an application for approvals under the Fast Track Approvals Act 2024 for the Barrytown Minerals Project – Southern Block [FTAA-2605-1238]

Reply Statement of Evidence of Pier Federici in relation to Mine Planning

**Attachment A: Further information on Timing of Wetland Construction,
Tailings Disposal Areas and the Project Footprint.**

Image: Long section and plan showing the position of the dredge at the mining face and an illustration of the minimum area of open mining void, as well as the tailings that will follow the dredge.

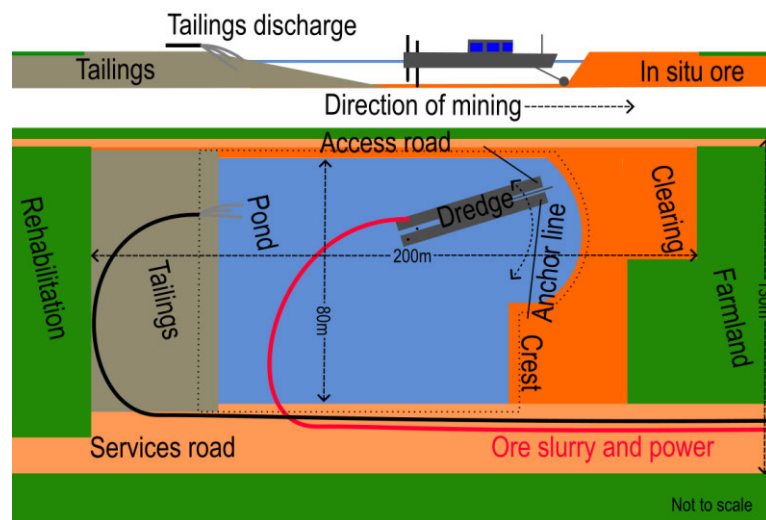
- 1 My name is Pier Federici.
- 2 I provided a statement of evidence dated 24 March 2026, which outlines my experience at paragraph 3.
- 3 I reconfirm that I have read the Code of Conduct for expert witnesses contained in the Environment Court of New Zealand Practice Note 2023 and that I have complied with it when preparing this evidence. Other than when I state I am relying on the advice of another person, this evidence is within my area of expertise. I have not omitted to consider material facts known to me that might alter or detract from the opinions that I express.
- 4 This reply evidence responds to the following matters raised by the Expert Panel in Minute 3.

- 6 The dredge path will be divided into a series of cuts parallel to the direction of mining. The width of the cuts depends on the dredge dimensions.
- 7 The angular position of the dredge is controlled by winches operating on the anchor line cables. The anchors will be positioned adjacent to the active

face and crest of the void. The anchors provide lateral movement. The dredge will pivot on the working spud. The position of the working spud is controlled and moves along the dredge to provide thrust required for the dredge and cutting head to advance. When the working spud is moving towards the rear of the dredge, the dredge advances. The fixed spud is used to stop movement while the working spud moves to the forward position.

- 8 Not shown on the image are the bunds to prevent unintended access to the working areas and surrounding the pond.
- 9 Tailings will be returned to the mining void by discharging the tailings onto the beach formed at the rear of the dredge pond. Testing will be required to determine whether open line discharge or a tailings stacker will be used for placing tails. Rehabilitation will commence with the placement of soils harvested from the area cleared in advance of the pond.

- 10 To minimise the open area, the returned tailings can be advanced so that the toe of the tailings approach the rear of the dredge. The angle of repose of the placed tails will impact the pond dimensions. The slope angle of the placed tails will need to be ascertained. The angle will be between 3 and 6 degrees. At 10m pond depth this equates to between 95m to 190m from the tailings beach to the toe of the tailings below the pond.

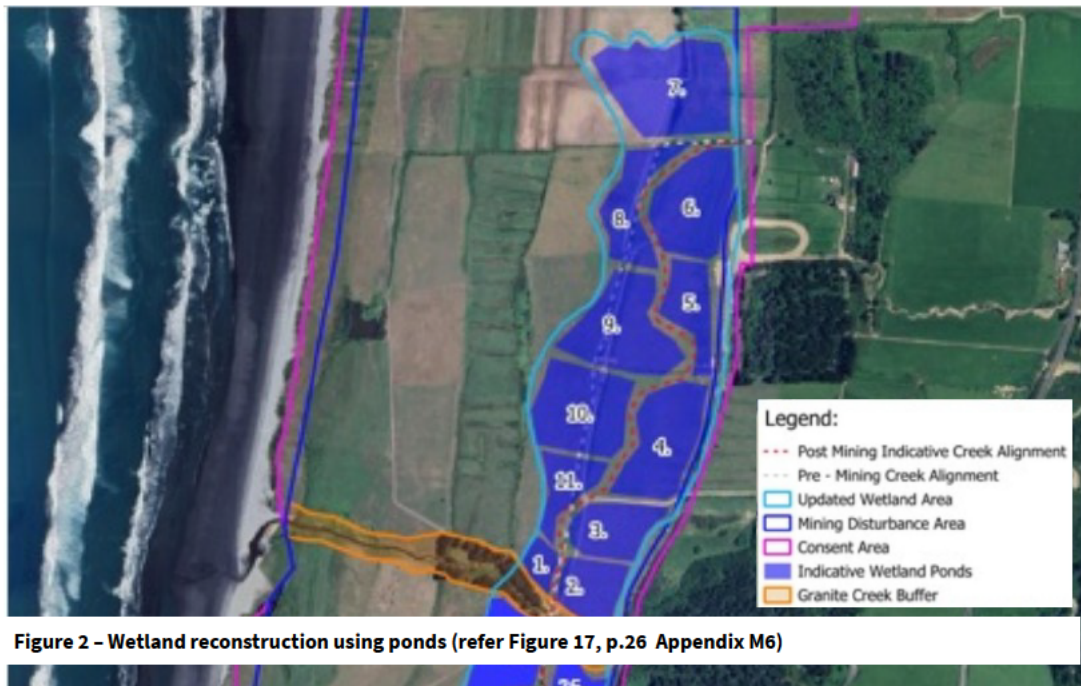
The Panel is unclear how the early stages of mining will fit within the proposed maximum open area of 16 ha. This needs to incorporate all open mining areas, any out-of pit tailings areas, borrow areas, and the construction of the proposed Stage 1 wetland (which, in and of itself, will exceed 30 ha). Additional information is needed to demonstrate how the matters set out above will work together operationally to fall within the proposed 16 ha open area.

Wetland construction will be undertaken progressively as mining advances across the site. On the northern side of Granite Creek potentially 11 individual cells (of various depths) will be formed (as shown in **Figure 2**). Cells will be gradually linked together to form the larger wetland complex as mining moves across the site. Cells will be planted and then allowed to fill with water as designed, noting that there is a large edge of planting on the side closest to the next mine strip.

This staged approach to the wetland construction ensures that the total disturbed area will not exceed the maximum 16ha limit for the project and allows for rehabilitation to be undertaken adjacent to the cells as mining progresses. Planting of the cells is to occur prior to ‘flooding’ for health and safety reasons.
